B. PUBLIC AGENDA ITEMS

TO: Planning and Zoning Commission
FROM: Evann Martin, Assistant Planner
DATE: January 4, 2022
RE: Destination Market Plat 7 – Final Plat

RE: Jordison Construction Site Plan

The Development Services Department is in receipt of a proposed Site Plan for Jordison Construction. Based on the review of the provided submittal materials, staff have the following comments:

GRADING PLAN

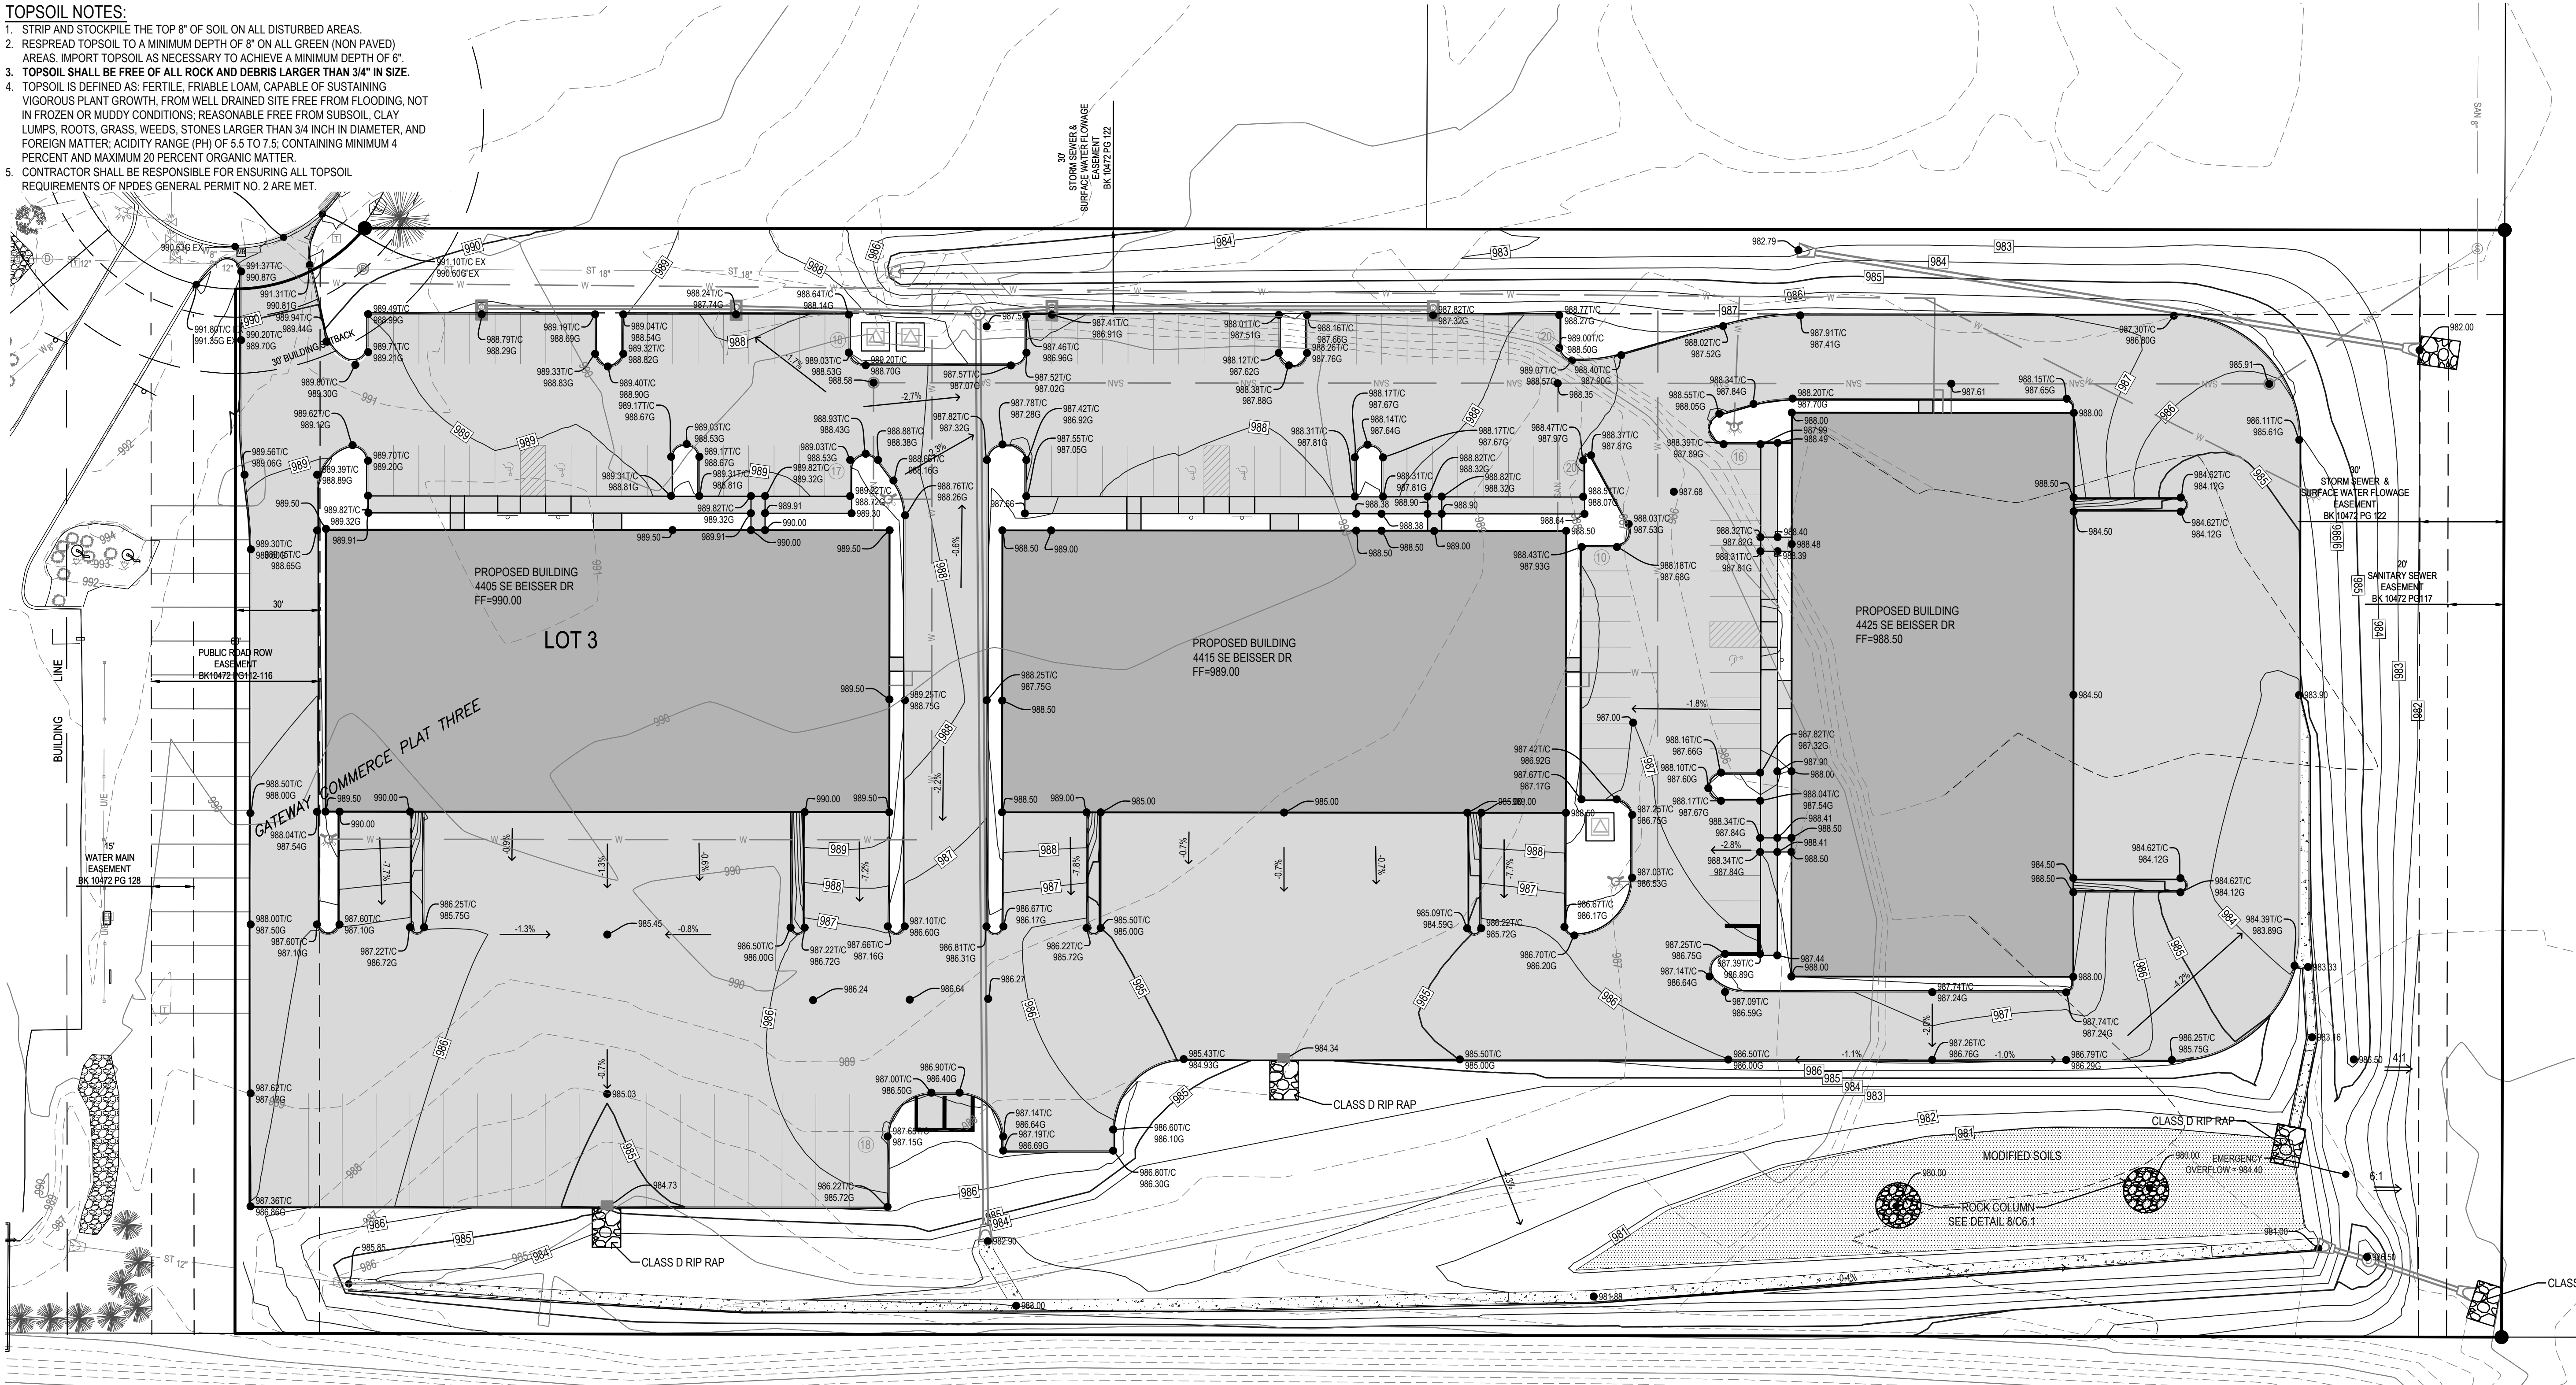
- ~~1. Please provide blown up detail for ADA parking spaces and ramps to show slopes and cross slopes. On the west ramp, please label the slope of the ramp. Looks like one of the slopes is not labeled.~~
- ~~2. Remove the flumes and grade to 2% slope.~~
- ~~3. A structure is needed at the 4' curb cuts along the south curb line.~~
- ~~4. FES structures will need protection. Provide protection at NW FES~~
5. Please provide more grade details along the east edge of the site. **Please provide.**
6. Where does the water flow after the FES structure along the east property line? Please provide more detail. **Staff may comment further upon receipt of the revised SWMP/review with Urbandale.**
- ~~7. Provide the percentage of flow across the site including in the swales.~~

1. Sheet C3.1 or C5.1: Show modified soil area.
2. Sheet C3.1: Any erosion control or energy dissipation needed at the curb cuts?
3. Sheet C6.1, Detail 8: Show mulch layer as a minimum of 3".

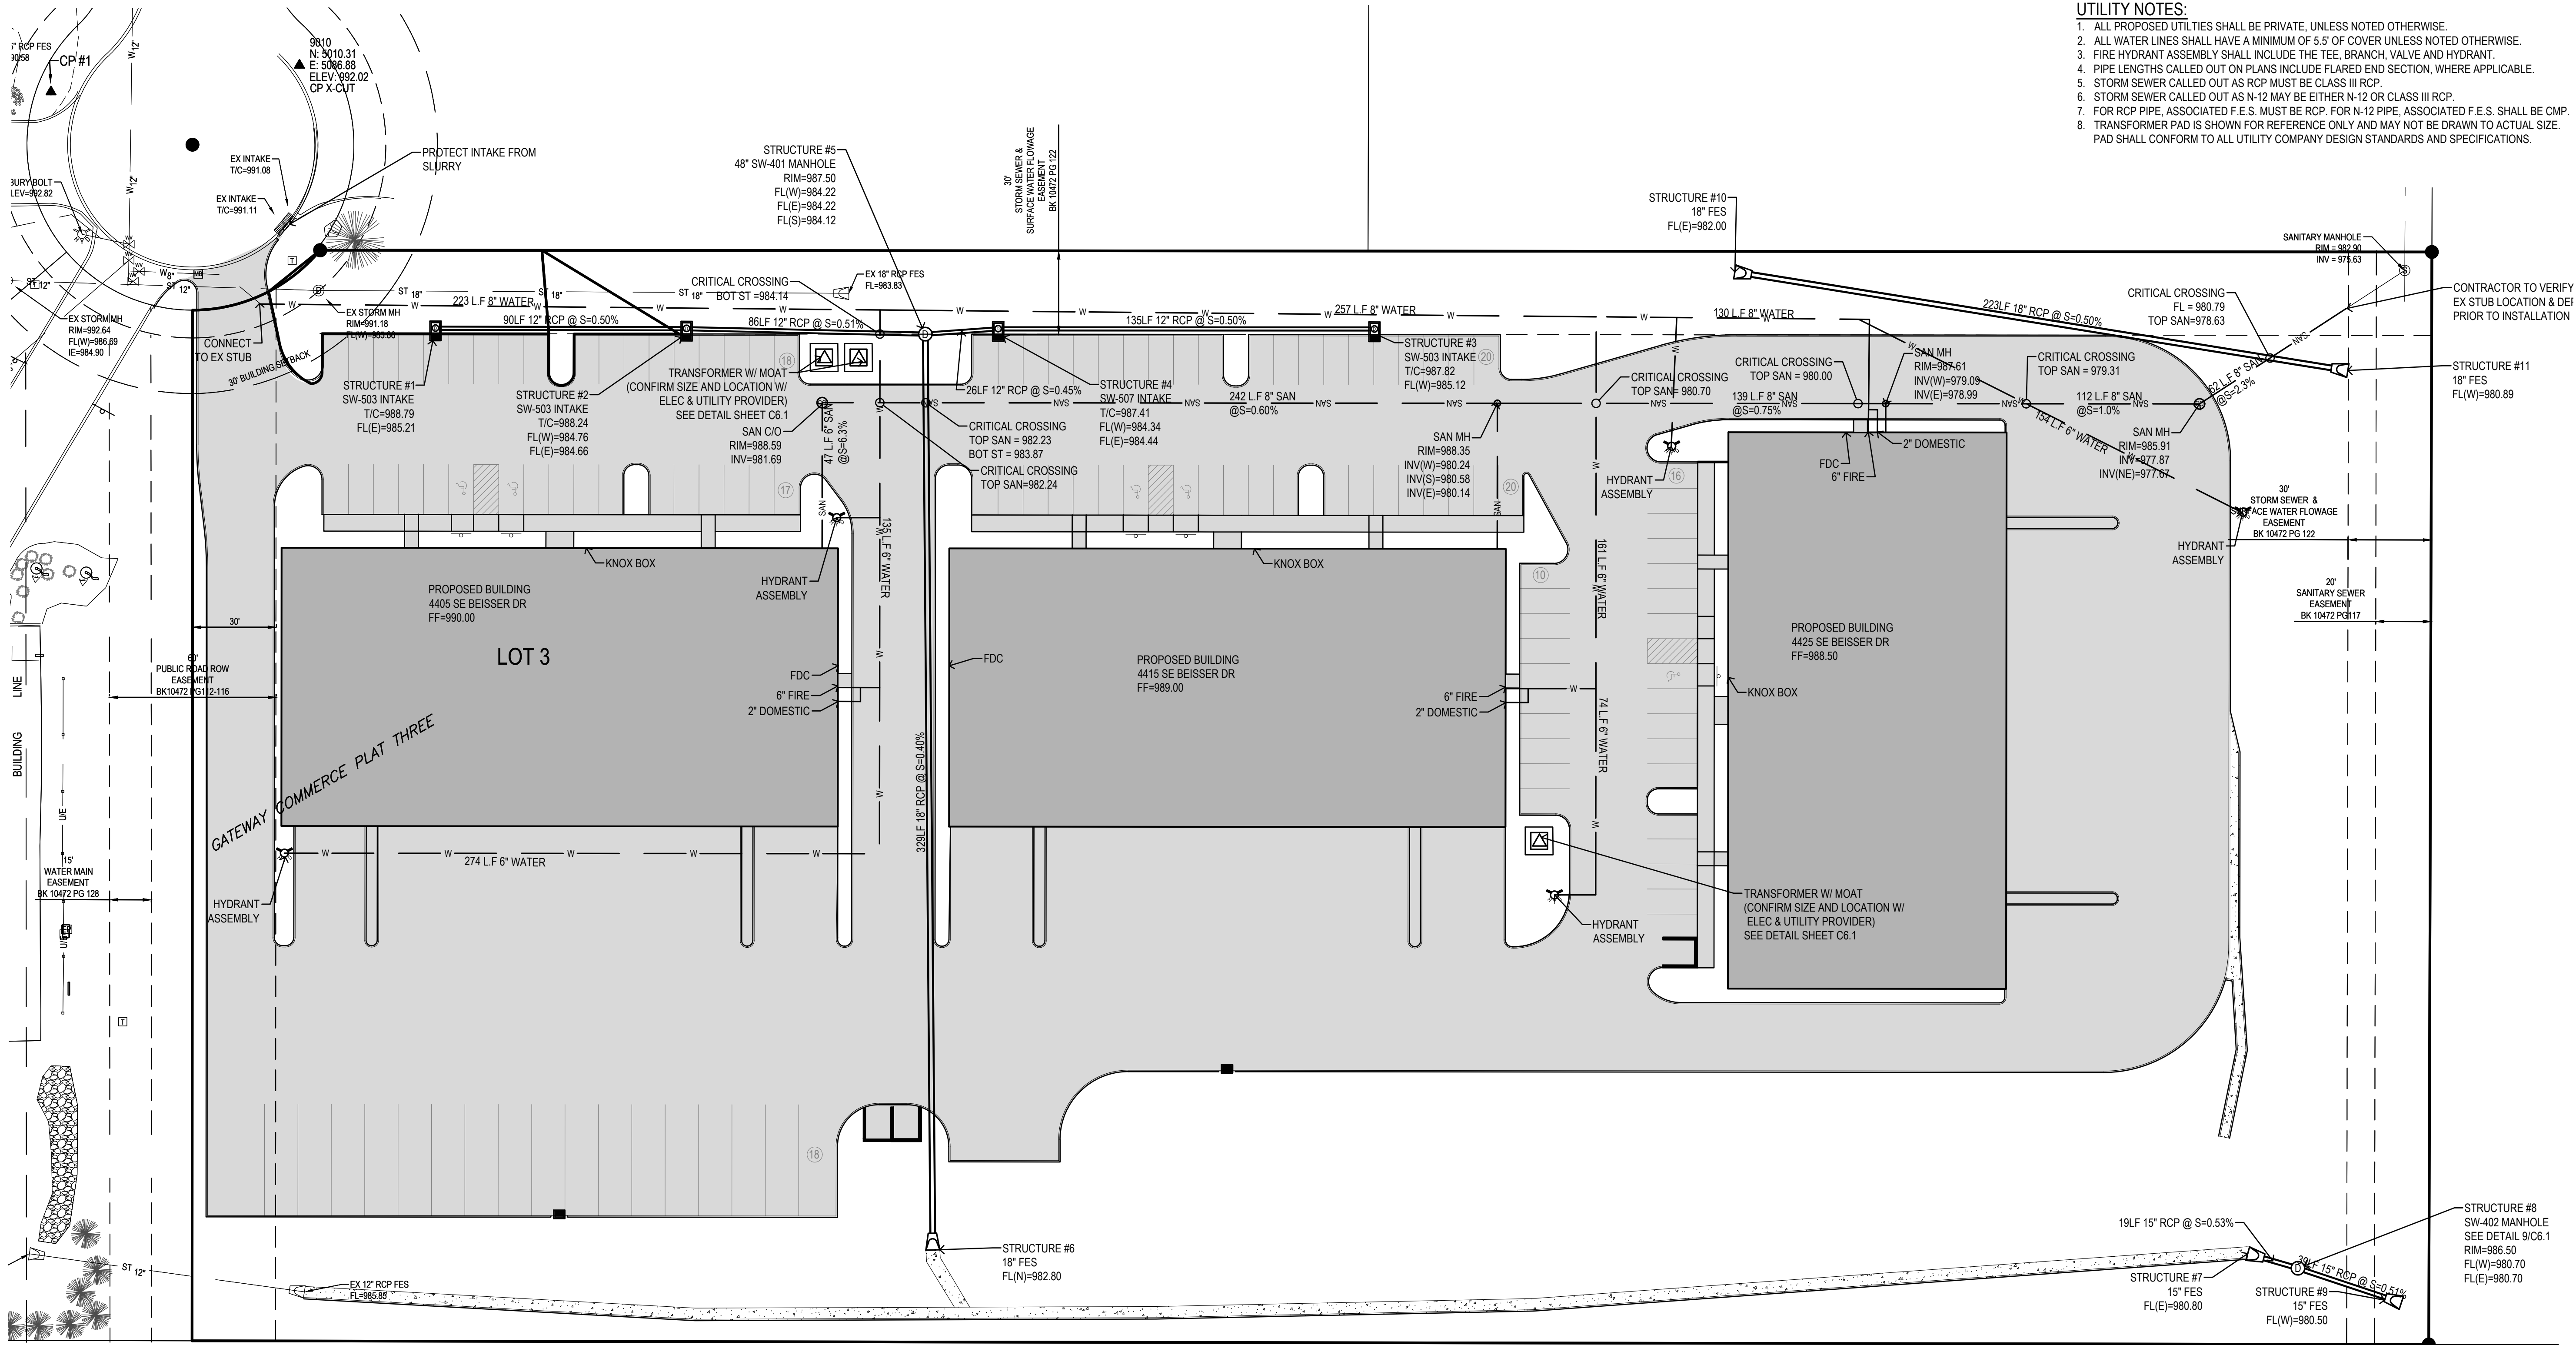
- ~~1. Provide roof drain connections.~~
2. Label 150' hydrant coverage in a 150' linear route, not 150' radius. The linear routes need to be shown along the path of travel for a fire truck and cannot be obstructed by parking, landscaping, etc. It looks like additional coverage will be needed for the east and west buildings. **Please label 150' hydrant coverage routes. Looks like another hydrant will be required for the east building.**

- ~~5. Sprinkler systems will be required for all buildings. Provide fire and domestic water service on the outside of each building. Please label size of the water lines.~~

7. ~~Label transformer locations.~~

8. ~~On the west side of the middle building, what is the dimension of the storm sewer pipe from the building? Staff would suggest shifting the pipe to the west to avoid conflicts with footings~~

9. ~~Show the sanitary and water services going into the building.~~

10. Are any auto service uses proposed or will there be vehicle pull in capability? If so, a sand oil separator will be required. **Are vehicles intended to pull into or park inside the buildings?**

14. What is the rock check dam? Where is the detail? **Staff will review upon receipt of revised SWMP/review of Urbandale.**

~~15. The proposed driveway looks to be coming into contact with the existing storm structure on the cul-de-sac of SE Beisser Drive. The structure and intakes will need to be modified to a driveway grate intake.~~

16. Add note to watermain connection to verify pipe size, depth and material.

17. Provide water valve at watermain connection for testing.

20. Show domestic and fire service with sizes to buildings with curb stop and valve on each 5' outside of building.

22. Provide existing manhole flowline elevations. Add note to core drill into existing MH and utilize Link-Seal or approved equal.

23. Will the proposed 6" service to 4405 be connected to the main utilizing a wye ahead of the 8" cleanout? If so, note on plans.

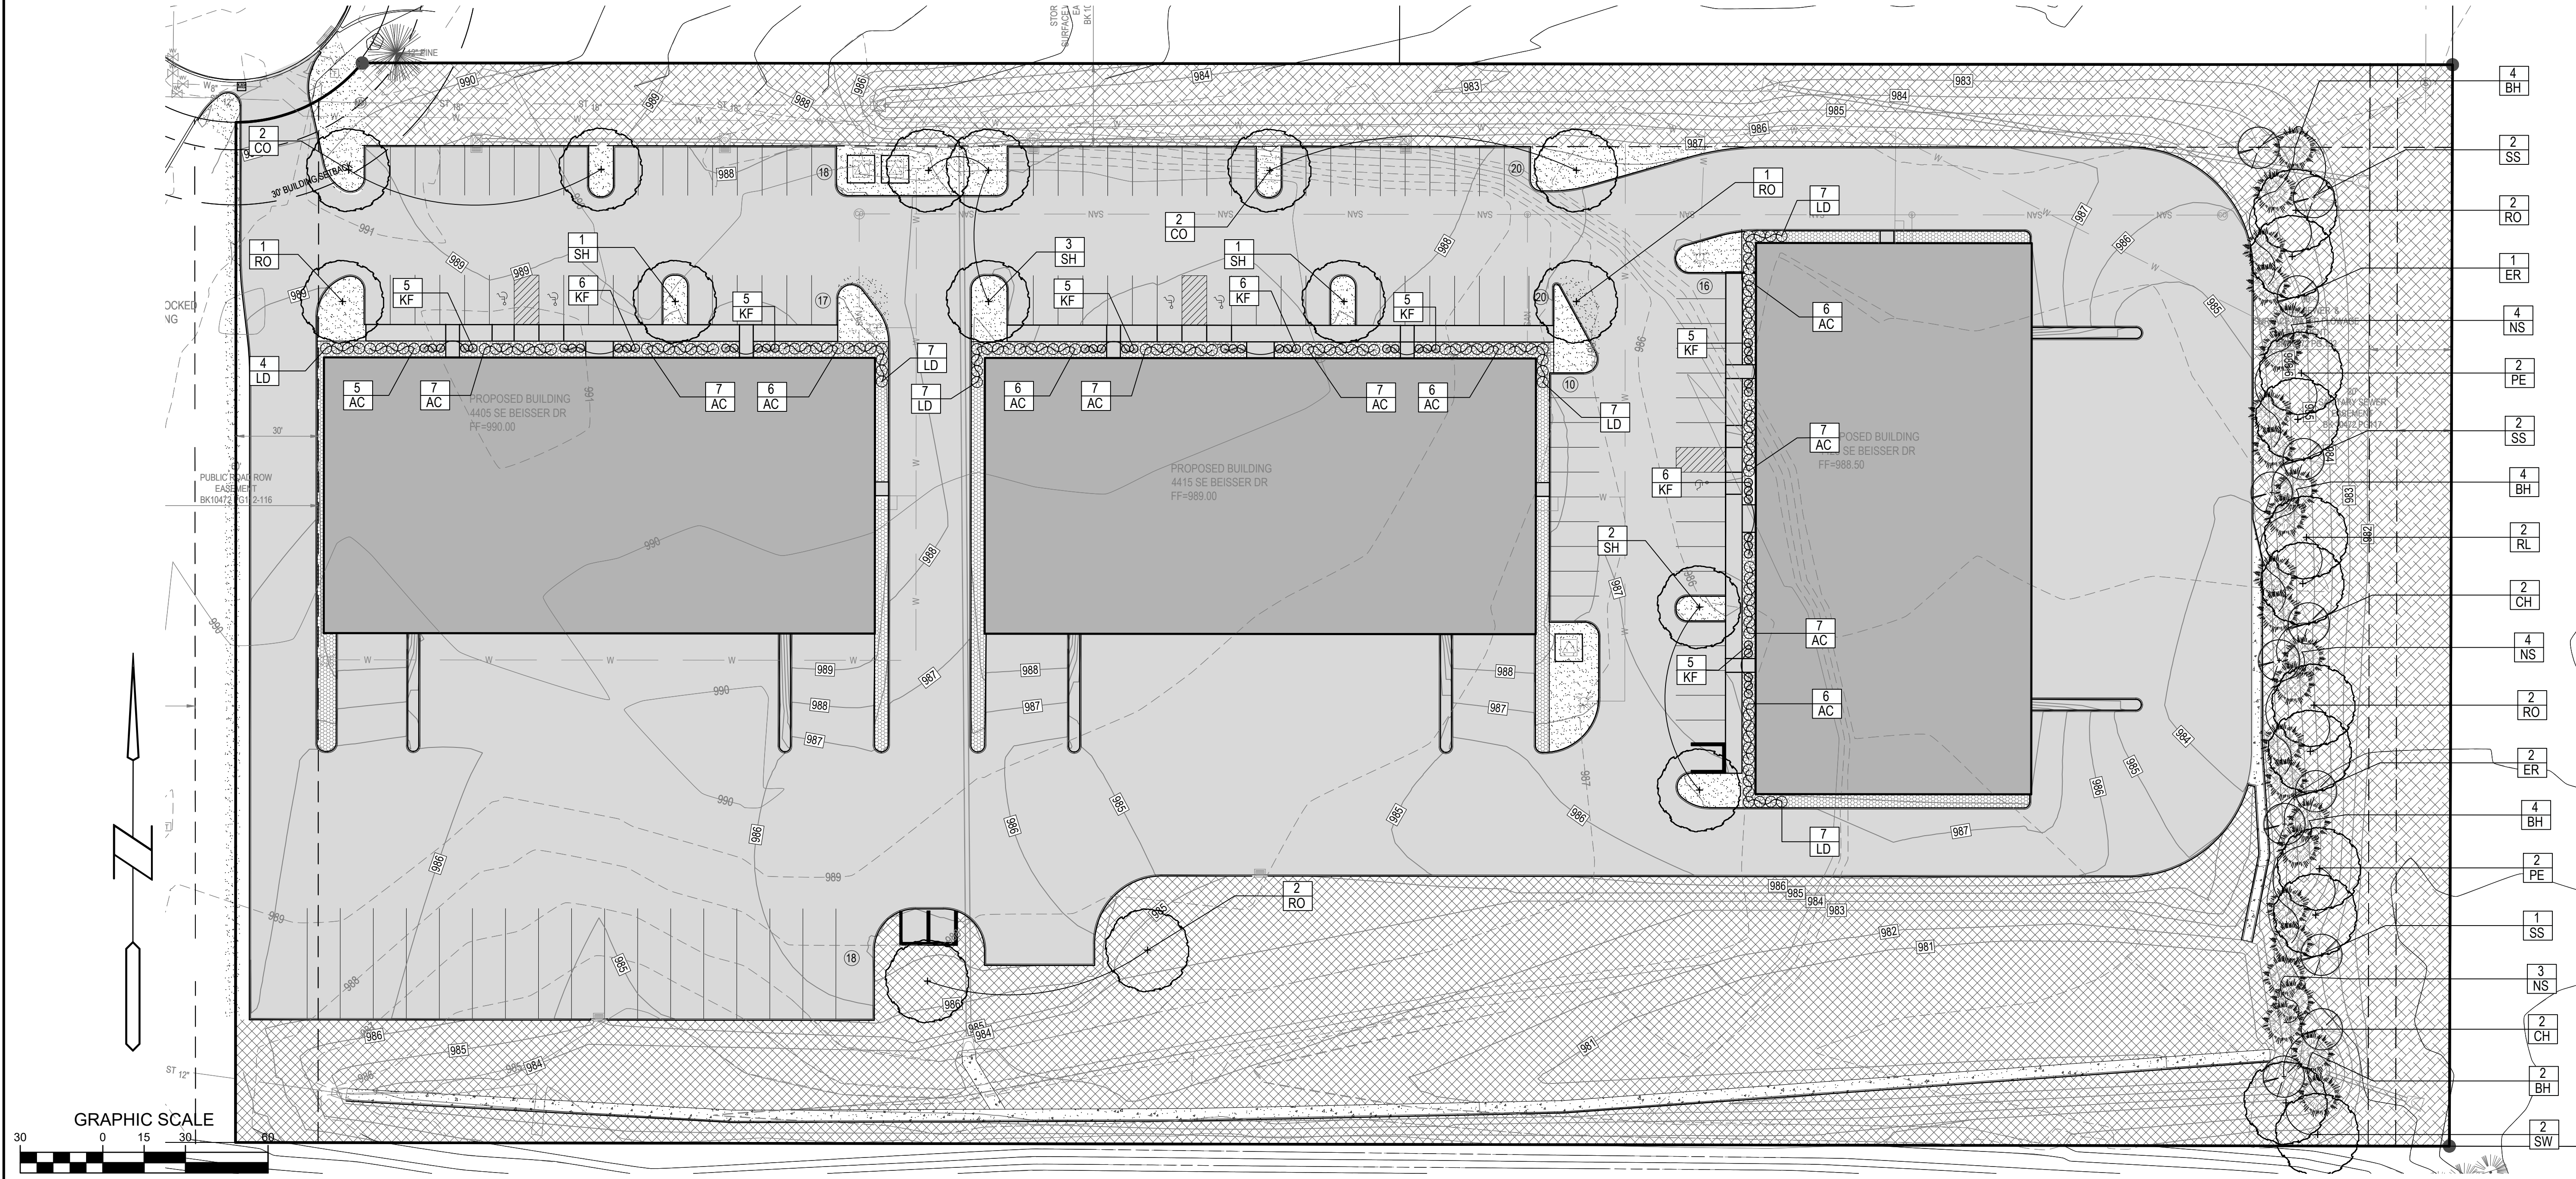
~~1. Please remove trees within islands that have a hydrant to avoid conflicts.~~

4. Screen transformers from the ROW with landscaping. Please provide on the west side of the north transformers.
